SGS-9-06

Comparison of Permeation Standards Among HySAFE, SAE and Japanese Regulations and Proposal to GTR

JASIC

Fig. 3

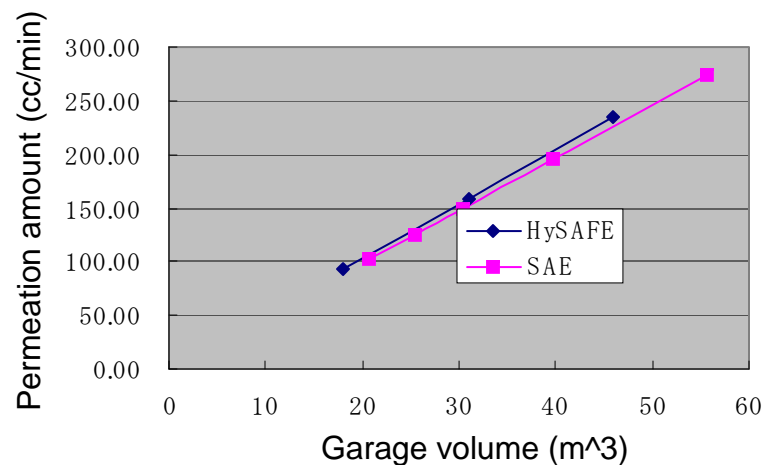
(i) Current gtr draft (Fig. 3)

150 cc/min@55°C

$$=150 \cdot (\text{Vehicle Length}+1) \cdot (\text{Vehicle Width}+1) \cdot (\text{Vehicle Height}+0.5) / 30.4$$

Fig. 5

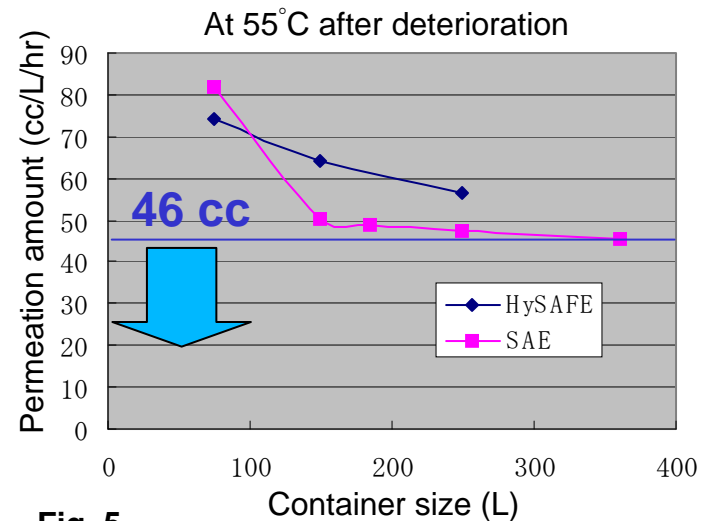
(ii) The definition is given with the permeation amount per liter of the container and the value is 46cc/L/hr@55°C in leakage/permeation test after gas cycle test (Fig. 5).

* If we define permeation amount in relation to garage volume and vehicle size, we have to manage the combinations of container size and vehicle size. We want to spare this management work.

*The value of 46 cc/L/hr@55°C takes into account a higher degree of deterioration compared to 5 cc/L/hr@15°C for new containers. Therefore it takes into account the actual performance of currently used containers and is applicable to these containers.

Fig. 2

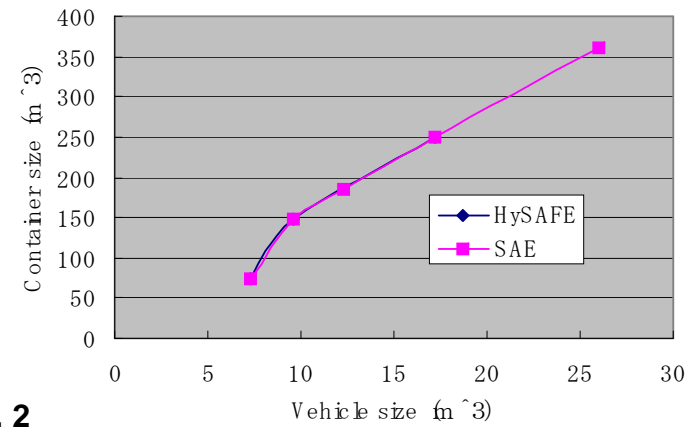
Fig. 2: In this review, we assumed that container size is the same for all vehicle sizes.

Fig. 3

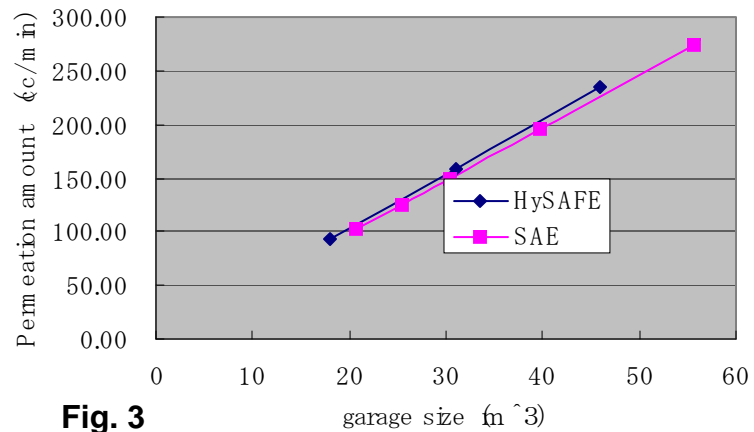
Fig. 3: Permeation amounts in relation to garage volumes (cc/min) are the same between SAE and HySAFE.

This is because HySAFE defines the permeation amounts of new containers according to vehicle sizes.
